FINAL DETERMINATION

CONSTRUCTION of MAJOR SOURCE

Mountain State Clean Energy LLC

Permit Application Number: R14-0038

Figure 1. MSCEC/Longview Ambient Air Boundary

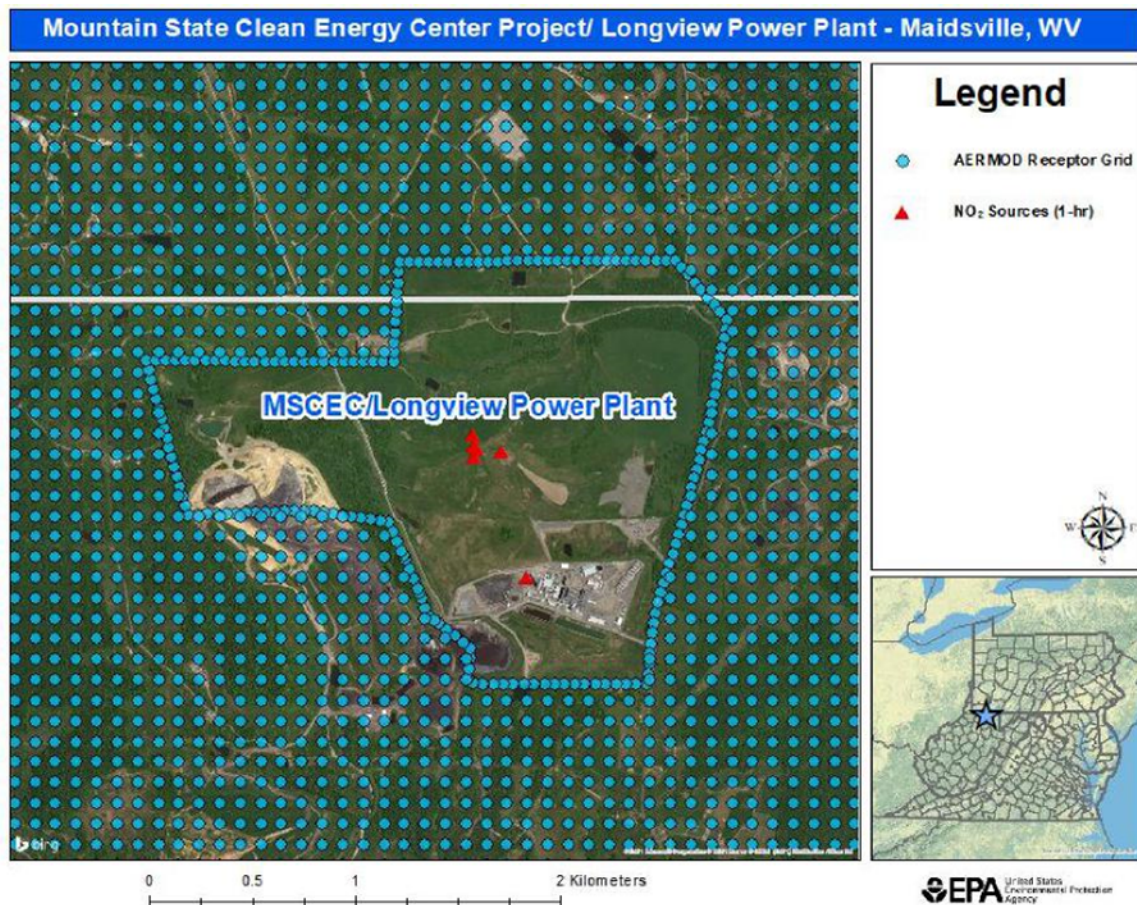
Figure 1 (next page) shows the model receptor grid used in the modeling analysis prepared by Ambient Air Quality Services, Inc and included in the electronic modeling files shared with the EPA. The area devoid of model receptors is the area considered to be under control of the facility where the general public is precluded access. This area is quite extensive. The boundary marked by the receptor grid surrounding the facility is approximately 9 km in length.

EPA believes the facility’s ambient air boundary is not properly defined by the model receptor grid. In all likelihood, the boundary demarcated by the model receptor grid reflects the facility’s property boundary and not the true ambient air boundary. To meet EPA’s current definition of

WVDAQ Response:

Figure 2. Charleroi, PA 1-hr NO₂ Background Values⁵

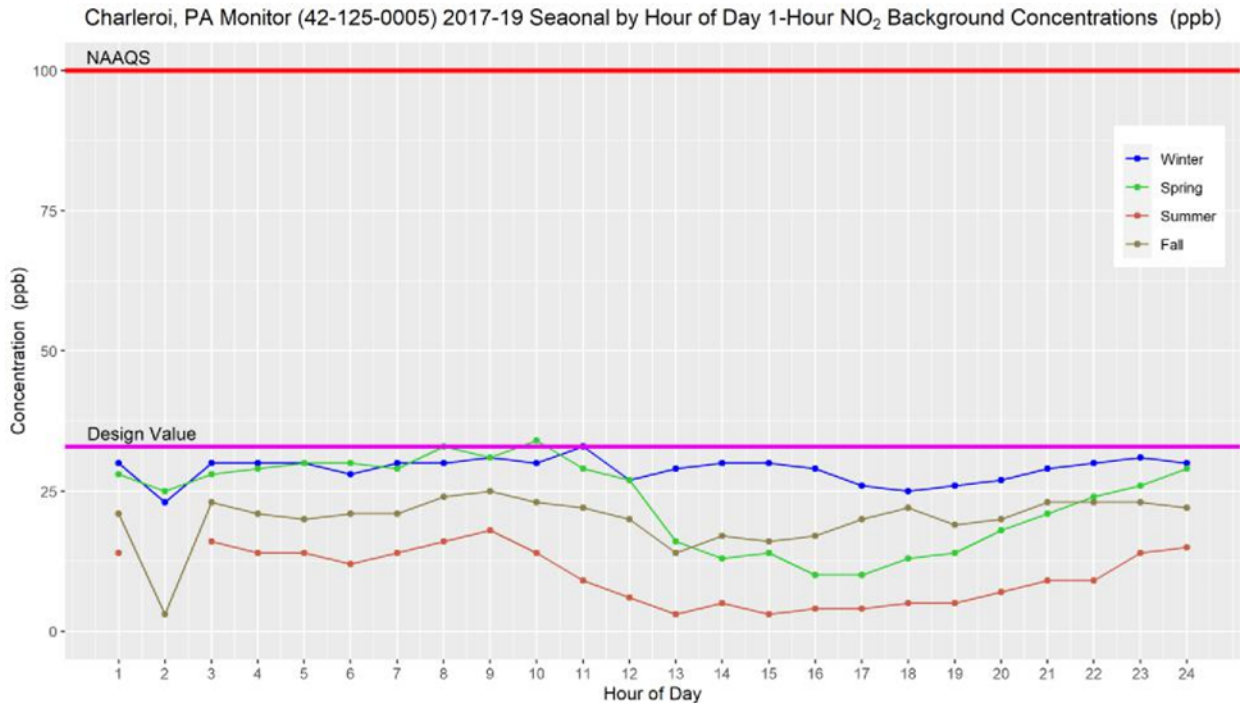
Figure 2 shows Charleroi's 2017-19 season by hour of day background 1-hr NO₂ values (in ppb) along with the monitor's design value. Using the season hour of day varying background concentrations may provide some lower background concentrations versus using the monitor design value. This may reduce final model concentrations.

WVDAQ Response: *MSCE utilized an appropriate, conservative, uniform background 1-hr NO₂ value in the modeling analysis. WVDAQ notes and acknowledges*

that other methods may be appropriate if an applicant or WVDAQ finds it desirable to refine the background concentration values.
